**ECN/PCN No.: 5172**
**For Manufacturer**

<b>Product Description:</b> DTCXO Temperature Compensated Real-Time-Clock Module With I <sup>2</sup> C Bus	<b>Abracon Part Number / Part Series:</b> AB-RTCMC-32.768kHz-EOZ9-S3	<input type="checkbox"/> Documentation only <input checked="" type="checkbox"/> ECN <input type="checkbox"/> EOL	<input checked="" type="checkbox"/> Series <input type="checkbox"/> Part Number
<b>Affected Revision:</b> Initial Release	<b>New Revision:</b> A	<b>Application:</b>	<input type="checkbox"/> Safety <input checked="" type="checkbox"/> Non-Safety

Product Package, Mechanical Dimensions (dimensions in millimeters):

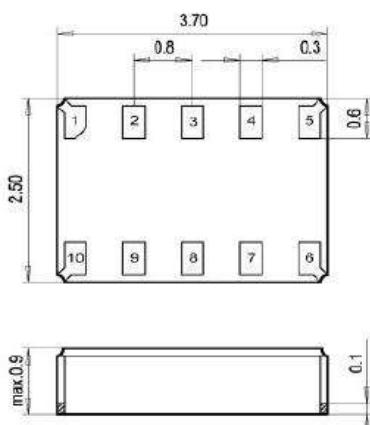
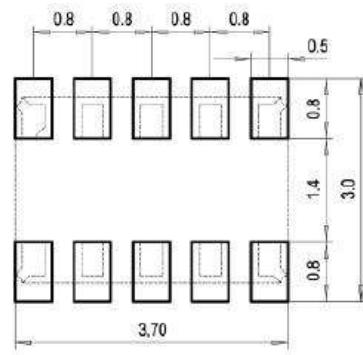
**Prior to Change:**

Product Package, Mechanical Dimensions (dimensions in millimeters):

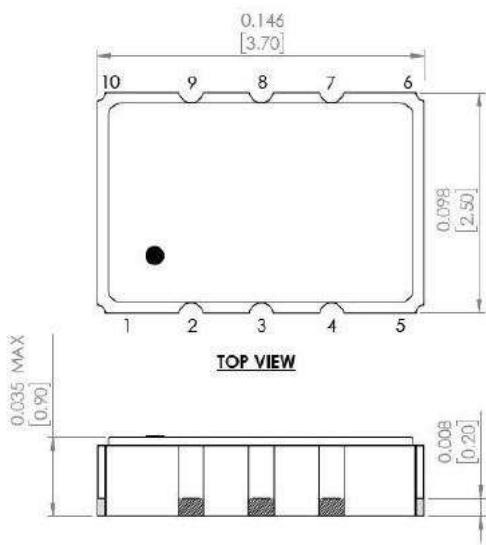
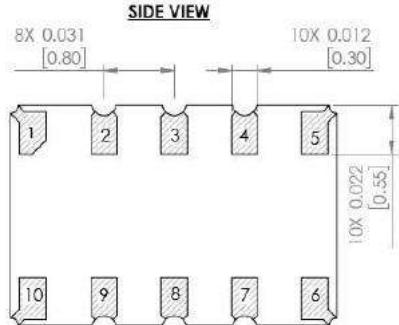
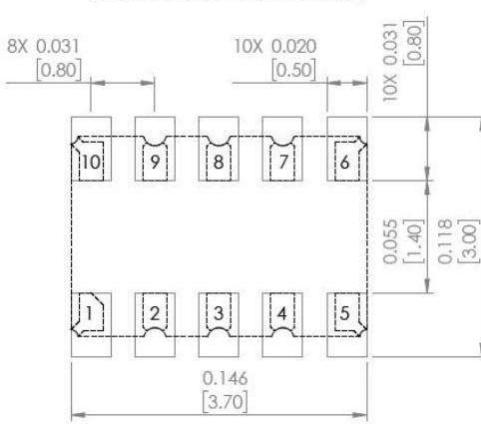
Updated package, adding side castellations.

The package mechanical dimension revisions do not impact the electrical performance of the device.
